# GE-Hitachi Nuclear Energy Americas LLC

MFN 07-371

**Subject: Response to Portion of NRC Request for Additional  
Information Letter Nos. 01, 54 and 71 Related to ESBWR  
Design Certification Application – Radioactive Waste  
Management Systems - RAI Numbers 11.2-4S01, 11.2-11S01,  
11.2.3-1S01, 11.3-3S01, 11.5-23S01 and 11.5-24S01**

### **Markup of Supporting DCD Revision 3 Pages**

Figure 11.2-1. Liquid Waste Management System Process Diagram\*  
 \*Similar to or Similar

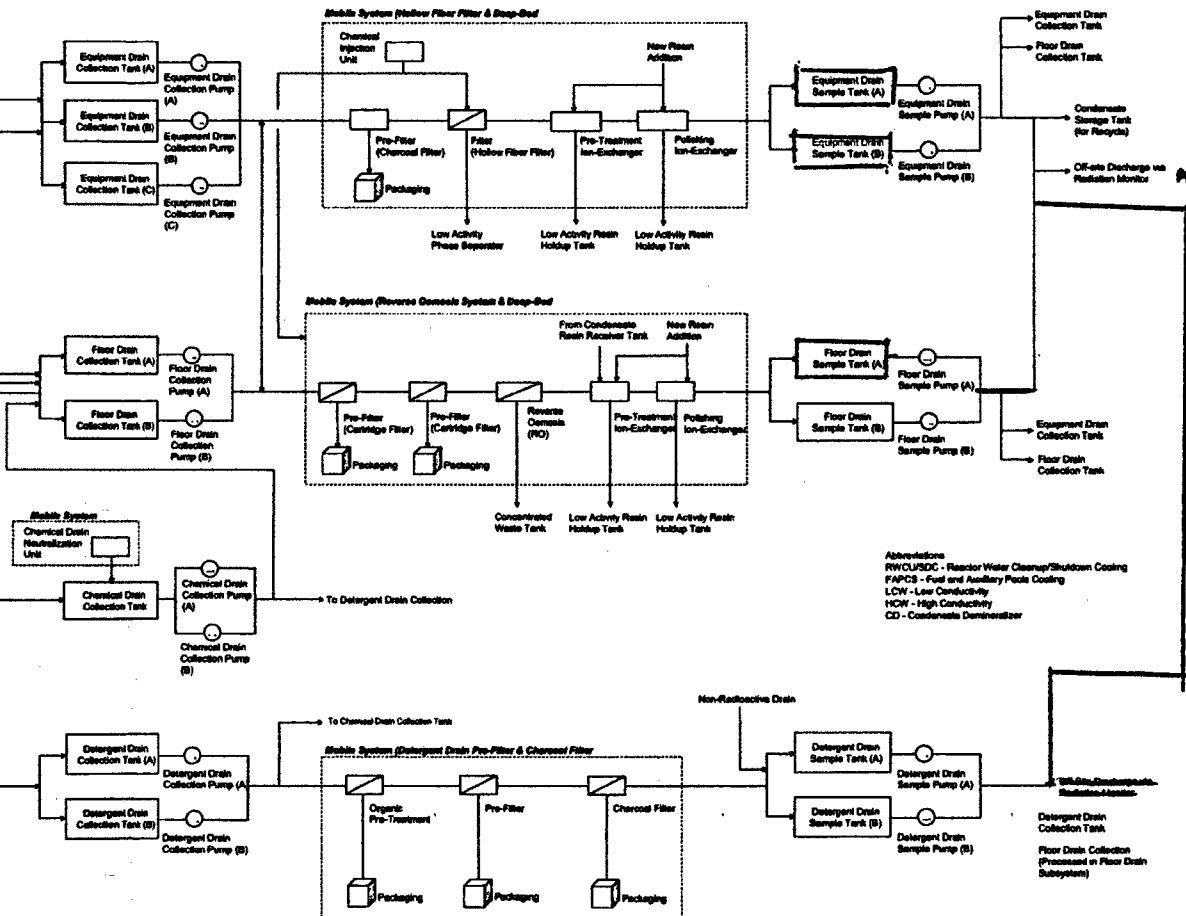
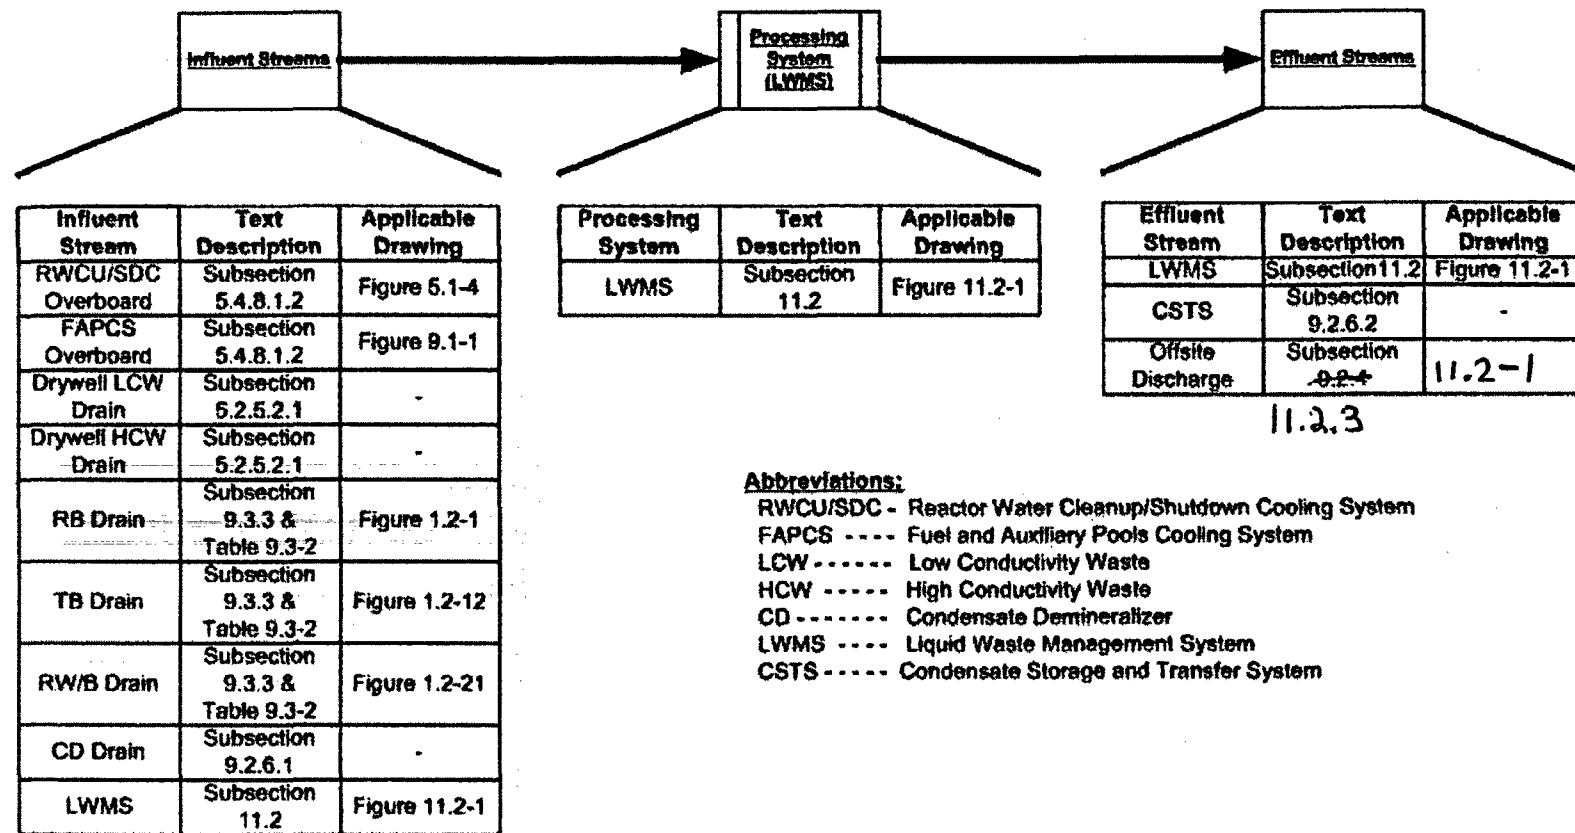
*DCD Tier 2, Figure 11.2-1, "Liquid Waste Management System Process Diagram," does provide sufficient detail to assess the system's adequacy. Locations of components relative to other plant components and buildings are not shown. Update the diagram to include sufficient detail to identify all sources of liquid input volumes (e.g., condensate storage tank collection berm and individual building sumps), the points of collection of liquid waste, the flow paths of liquids through the system including all bypasses, and the specific points of release of liquid effluents to the environment (e.g., interface COL item with circulating water system), consistent with the guidance of Standard Review Plan (SRP) Section 11.2, Rev. 2, July 1981, Review Criterion III.1.*

*In RAI 11.2-11, the staff requested additional detail to be provided for Figure 11.2-1, "Liquid Waste Management System Process Diagram." For example, the diagram did not show sufficient detail to identify all sources of liquid input volumes, the points of collection of liquid waste, the flow paths of liquids through the system including all bypasses, and the specific point of release of liquid effluents to the environment. The level of details should be sufficient to allow staff review in accordance with the guidance of SRP Section 11.2, Rev. 2, July 1981, Review Criterion III.1. In its response the applicant stated that the DCD Tier 2 would be revised to include a new Figure 11.2-2, "Liquid Waste Management System Process Stream Information Directory." Additionally, a description of Figure 11.2-2 was added in Section 11.2. The staff reviewed the revised figures in Revision 3 of the DCD Tier 2, and still could not find the specific point(s) of release of liquid effluents to the environment (e.g., interfacing with the circulating water system).*

DCD Tier 2 Chapter 11 will be revised to include a new Figure 11.2-2, "Liquid Waste Management System Process Stream Information Directory." Additionally, a description of Figure 11.2-2 has been added in Section 11.2. These attached improvements to the DCD are consistent with the guidance of Standard Review Plan (SRP) Section 11.2, Rev.2, July 1981, Review Criterion III.1.

The DCD will be revised to identify the specific release points to the environment.

DCD Tier 2, Subsections 11.2.3, 11.2.2.2, Figures 11.2-1 and 11.2-2 will be revised as noted on the attached markup in Enclosure 2.
